ADDENDUM NO. 04

PROJECT: BRADFORD CSD - 2023 CAPITAL IMPROVEMENT PROJECT

DATE: 04/04/2025

Drawing Number: MB A800

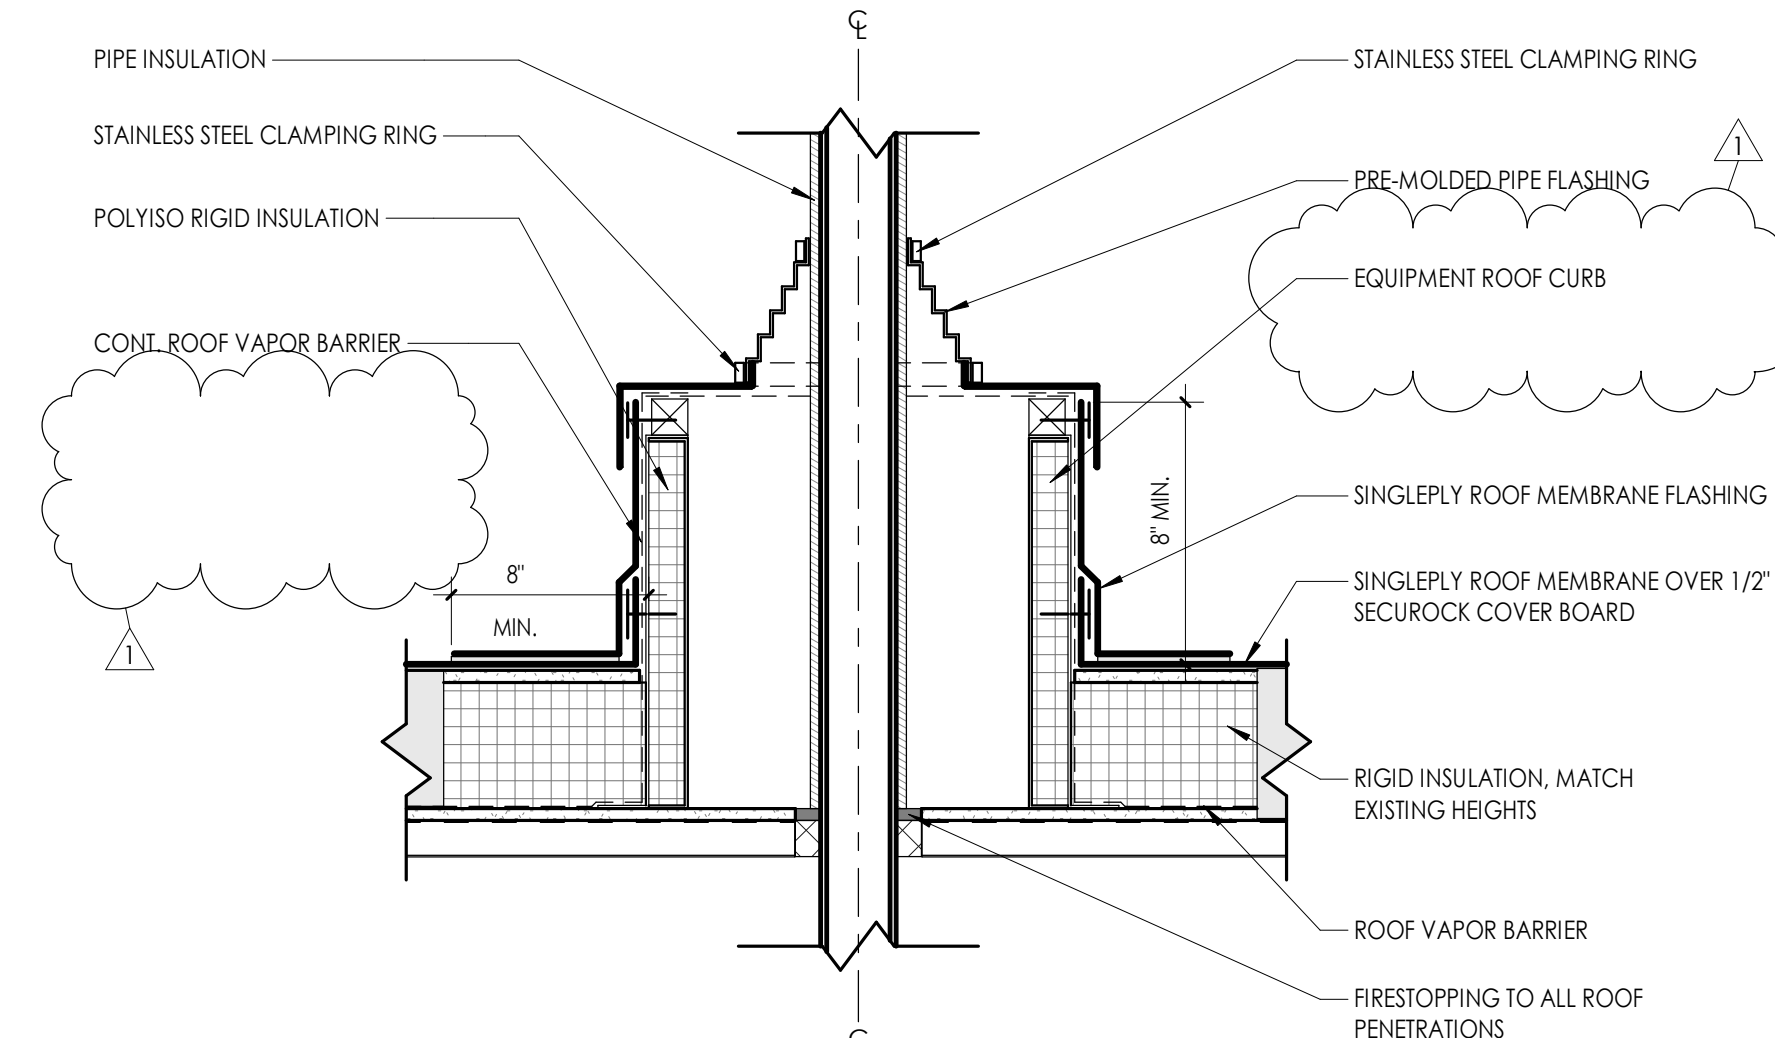
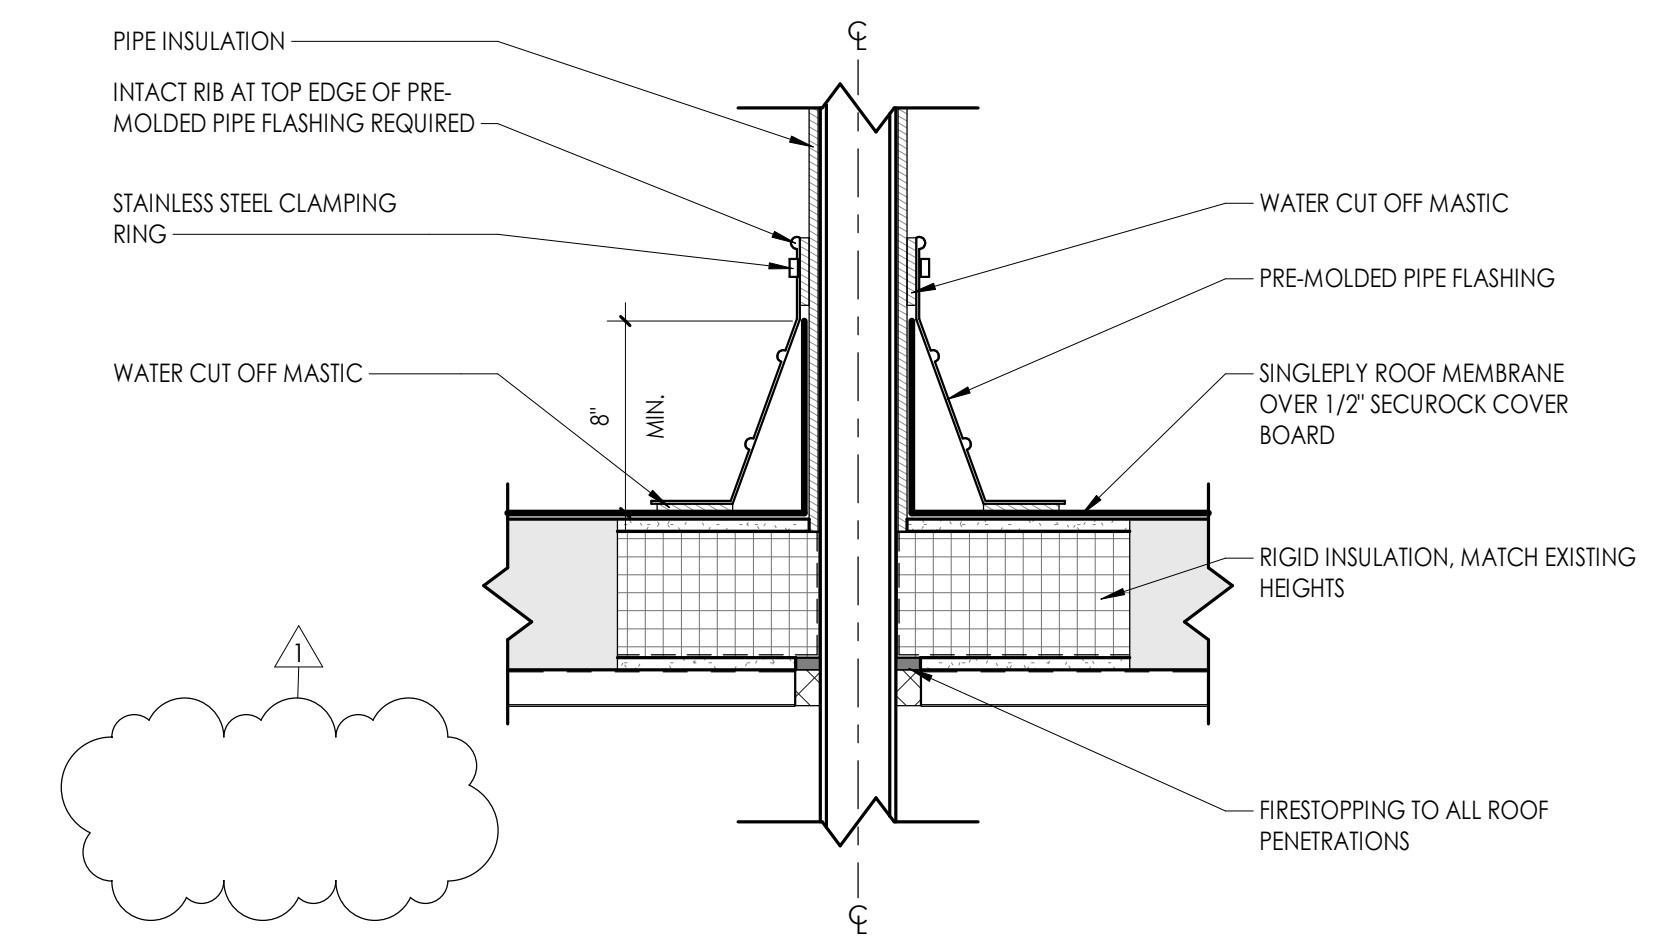
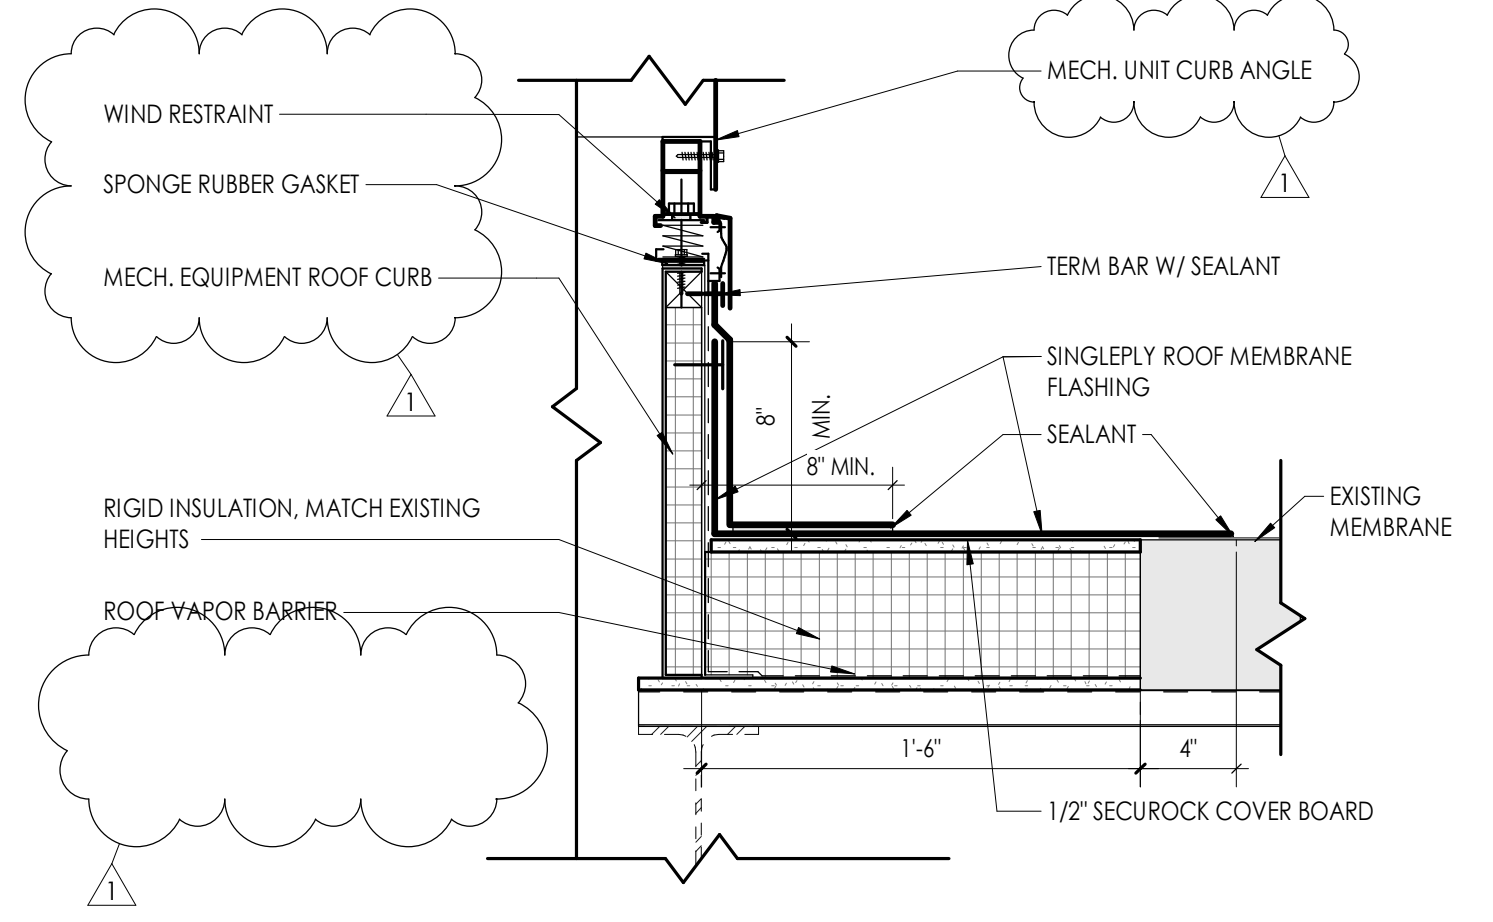
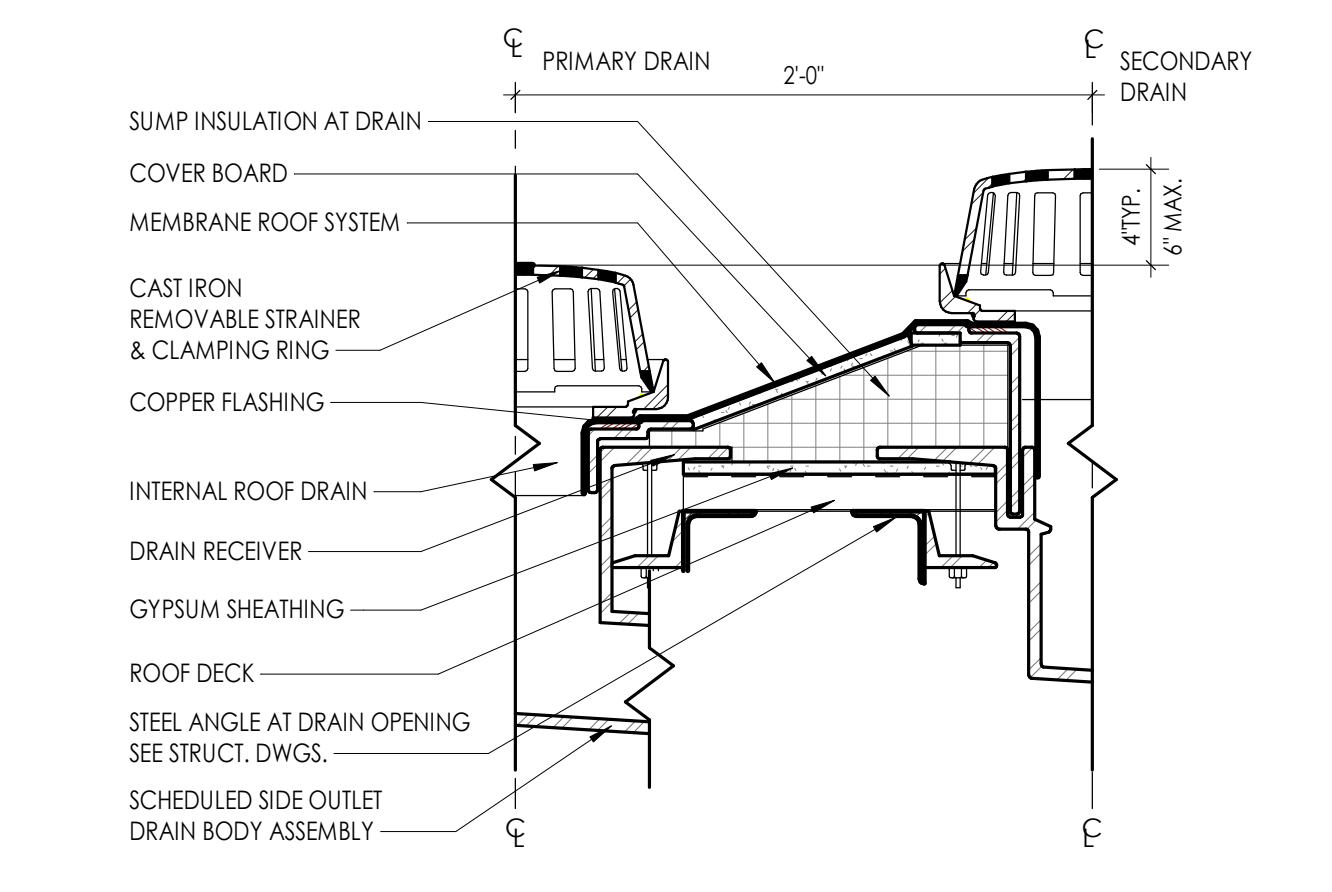
QUESTION: Please clarify the scopes of work for the GC and MC as it pertains to the roof work required for installation of equipment curbs, rails, and pipe portals. Currently shown and noted on MB A-202 & 800 and on MB H-202.1, 202.2, 202.3, 202.4, H302.1, 302.2, 302.3, 302.4

| MB-A800 | REVISE NOTES TO CLARIFY CONTRACTOR SCOPE OF WORK. |

RESPONSE: All work associated with mechanical work is the responsibility of the mechanical contractor. This includes installation of curbs, rails, and pipe portals. The mechanical contractor is also responsible for cutting, patching, and sealing of roof openings for mechanical equipment. The only work by the general contractor associated with mechanical work will be the structural support steel below the deck as necessary (see RFI FC-05 attached).

1 FIRST FLOOR DUCTWORK PLAN - AREA 4
 H201.4 1/8" = 1'-0"

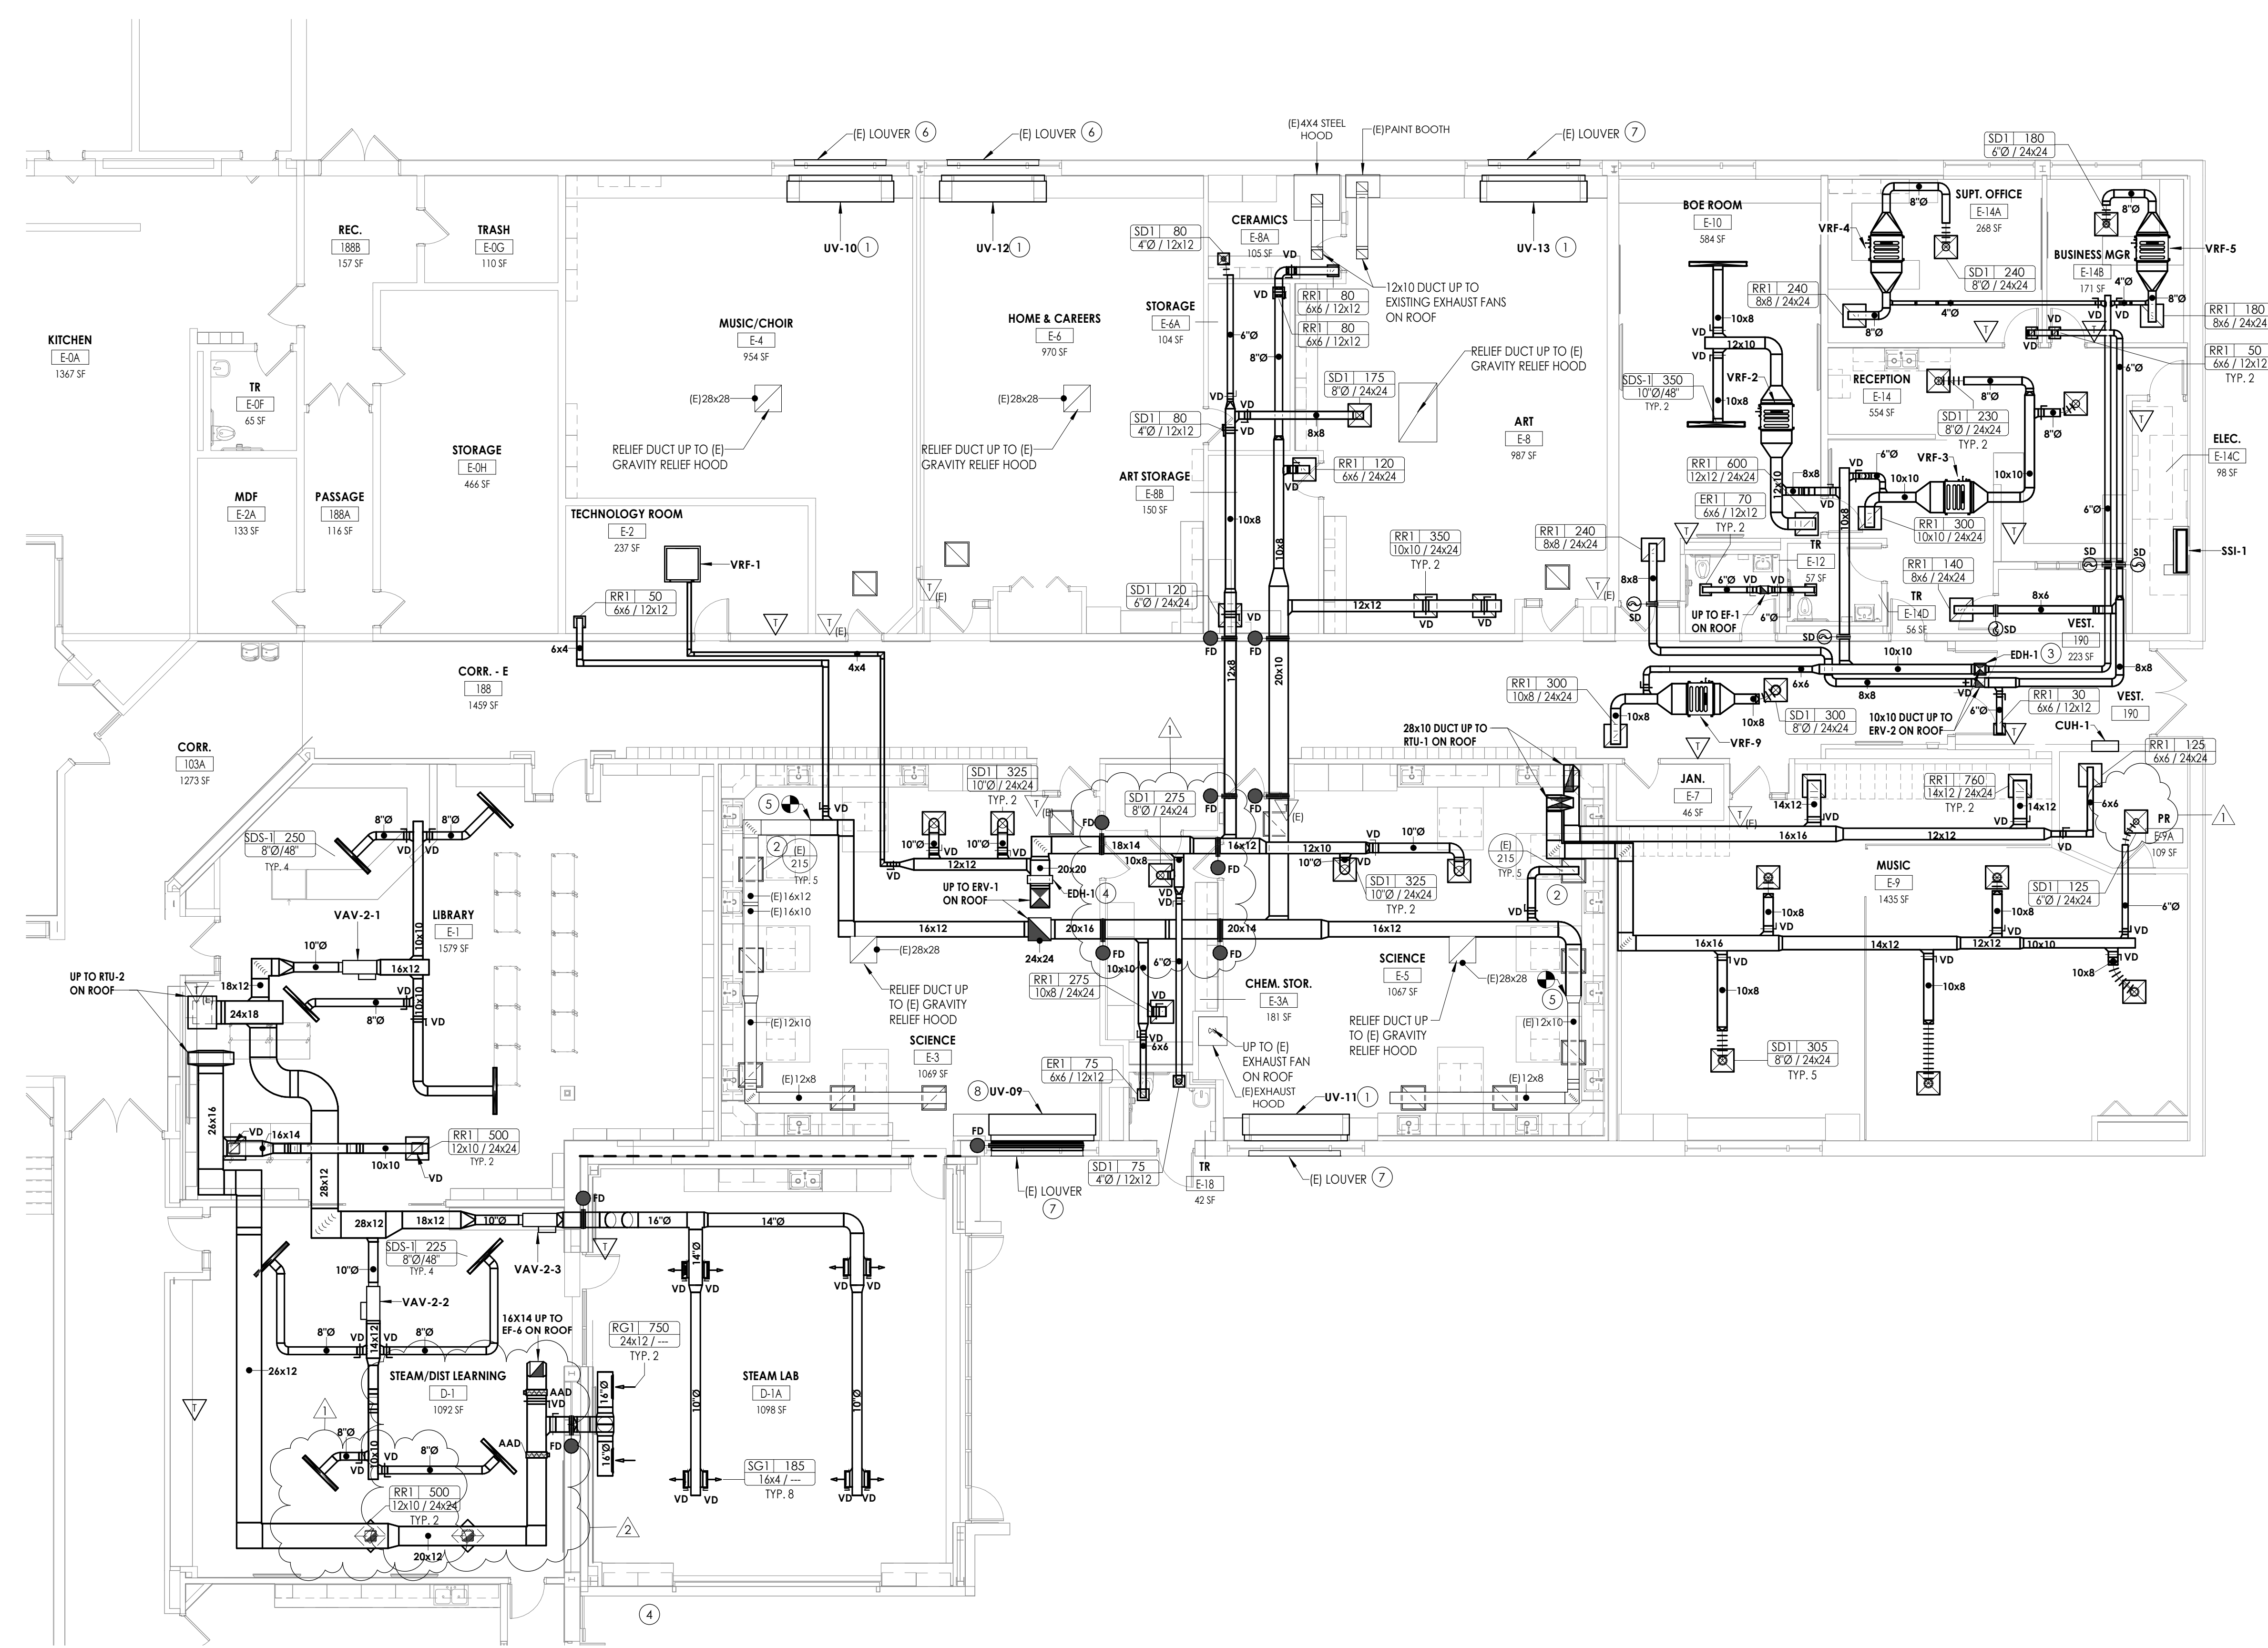
| MB-H201.4 | DUCT SIZE CHANGE. |
